Our Ref: 35437-006-01
Your Ref: MCUI 2026_5936/1

**Information Request Response – Development Application MCUI 2026_5936/1
Material Change of Use for Solar Farm (including ancillary device for storing and
releasing energy)
6868 Captain Cook Highway, Killaloe – Lot 32 on SP332240**

Visual Assessment Report

Proposed Solar Farm

PROJECT ID:	ALKIRA SOLAR FARM & BESS INSTALLATION	SHEET:	2 / 5
PROJECT ADDRESS:	6730 CAPTAIN COOK HIGHWAY, KILLALOE, QLD 4873	DRAWING TITLE:	SITE LAYOUT PLAN
DRAWING ID:	ALKIRA_SOLAR_&_BESS_G-1.0_DD	DRAWING REVISION:	H

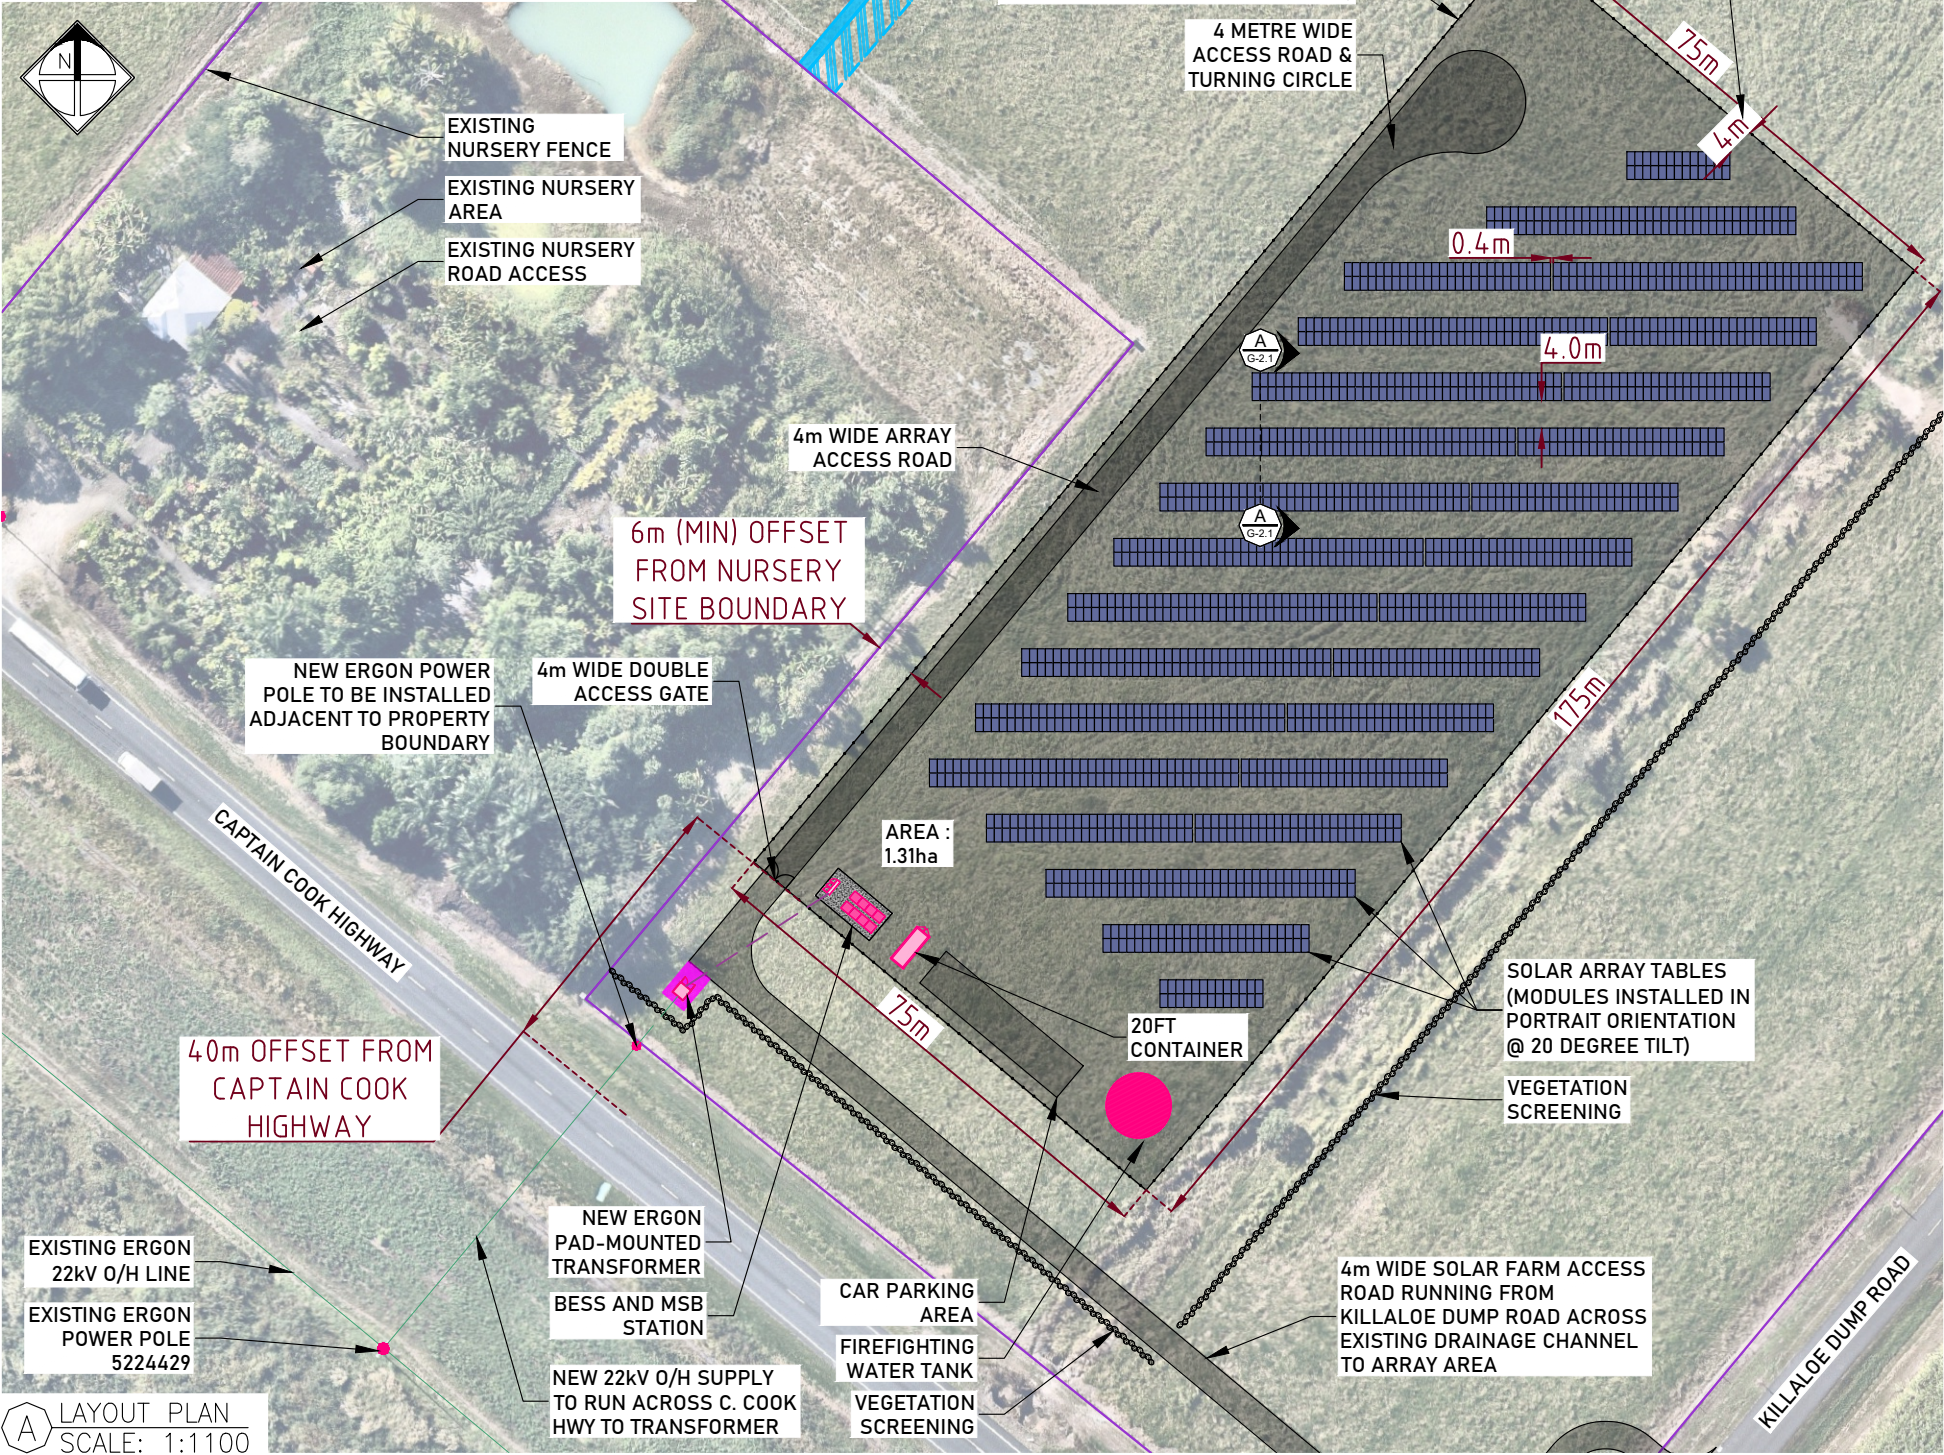
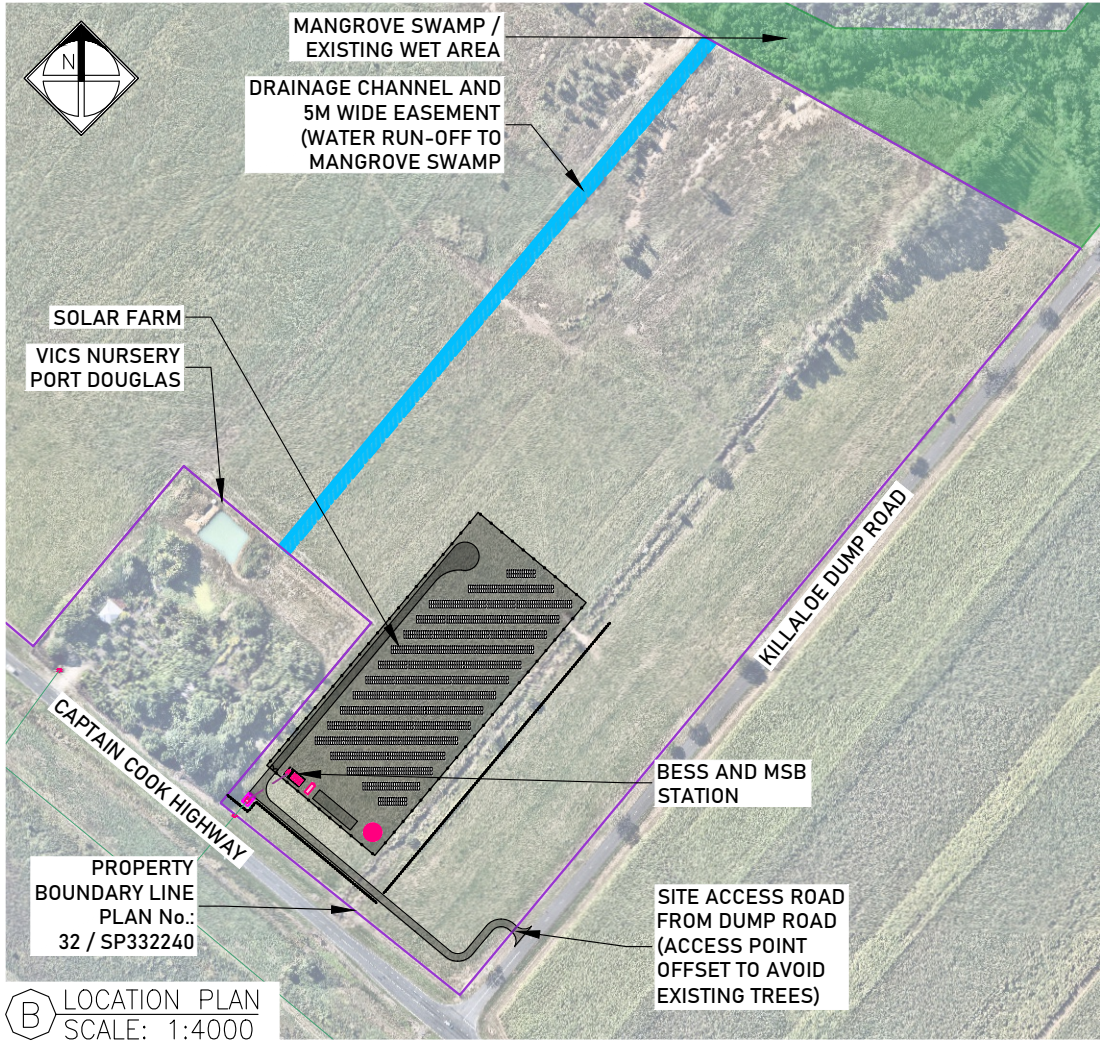
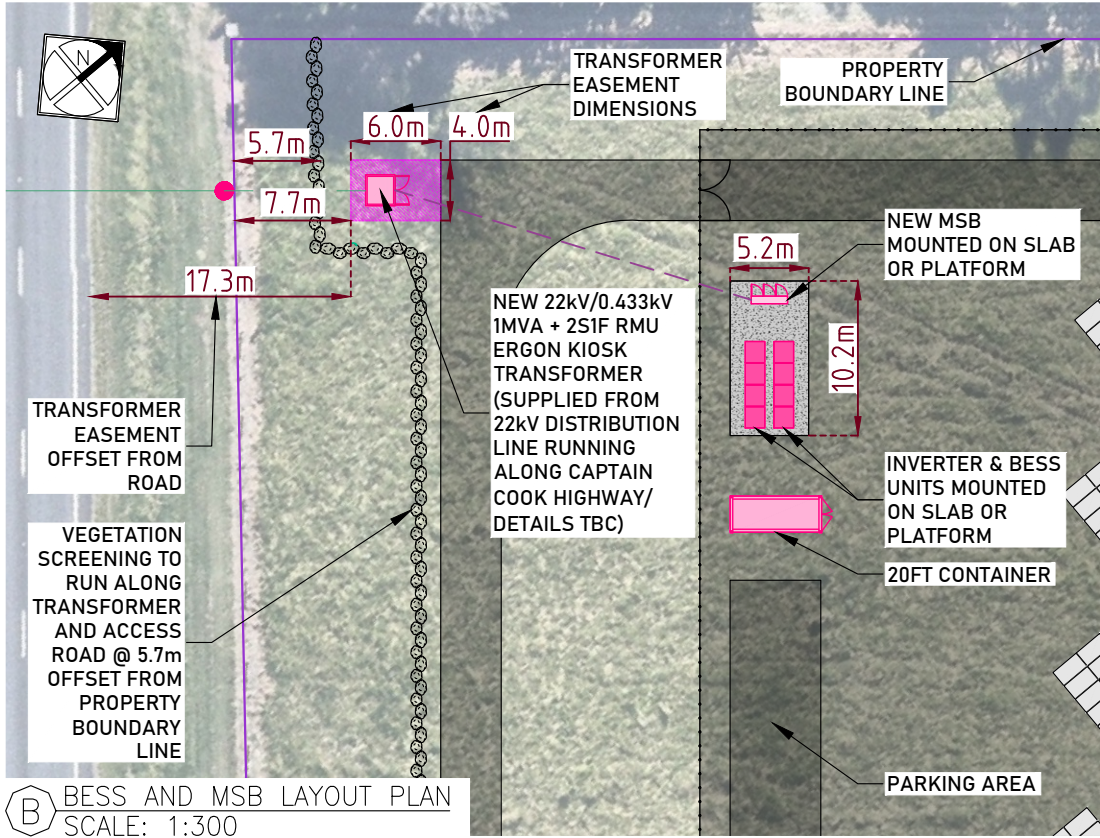
From the time that the original application material was submitted with Council, ongoing design revisions have been occurring. The changes primarily relate to the repositioning of the Padmount Transformer closer the Captain Cook Highway frontage to allow improved accessibility and simplified integration into the existing electrical network in accordance with Ergon Energy's requirements and the reduction of the overall footprint of the facility. Due to improved efficiencies and other design considerations the number of solar panels has been reduced from 2,496 to 1,664.
